# The HEARTHSTONE ON WOODLAWN - DPD PROJECT # 3006394 & 3006399

Design Review Board Recommendation Meeting - February 25, 2008

Response to Correction Letter dated September 4th by Shelley Bolser  
Project Number# 3006394 and 3006399  
Site Address: 6850 and 6870 Woodlawn Ave NE

WEST BUILDING: ENLARGED PLAN AT LOBBY ENTRANCE

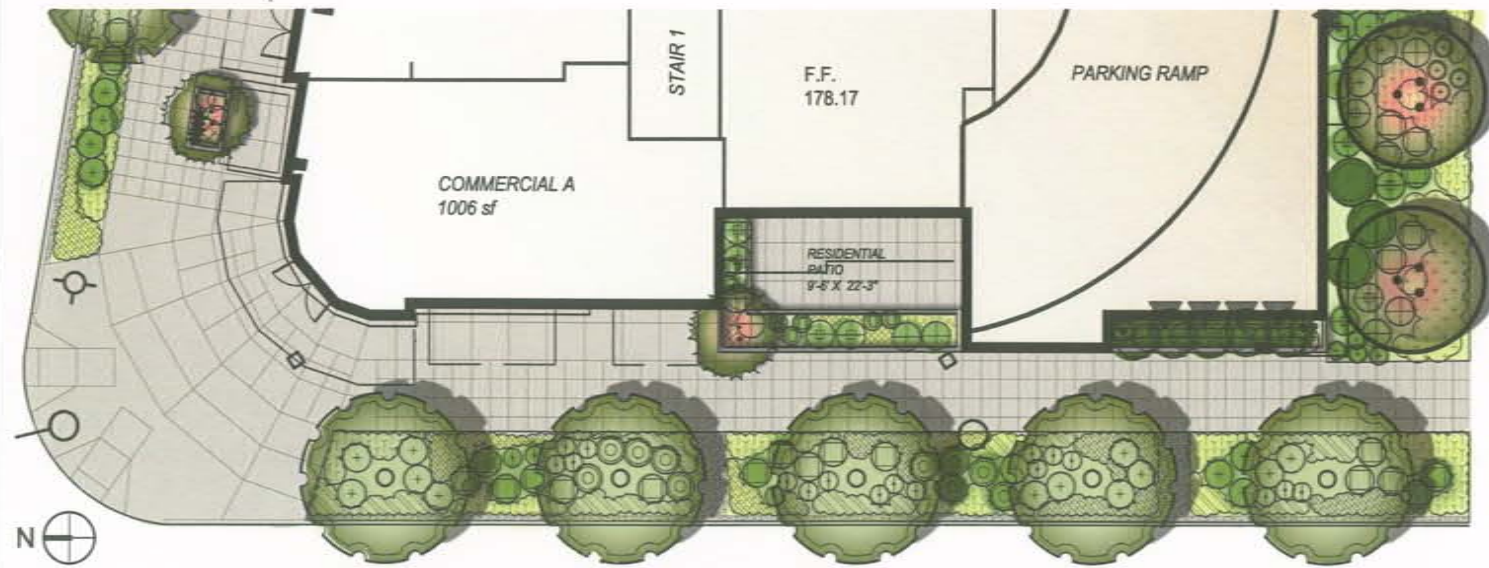
a. The landscape plan includes a planter box with a tree between the sidewalk area and the proposed area in the lobby. The landscape planter should include low shrubs only, in order to provide visual interaction between the lobby area and the sidewalk.

b. Please clarify if the lobby area would include seating adjacent to the window

Response:  
a. The planter box to the north of the residential entry has been replaced with a low wall. The planter box to the south of the entry has been deigned with low shrubs and a small tree which have been specified to provide visual interaction between the lobby and the sidewalk.

b. The lobbies of both east and west buildings are designed to provide seating, adjacent to the windows, to provide direct, visual interaction with the streetscape. See sheet A402.
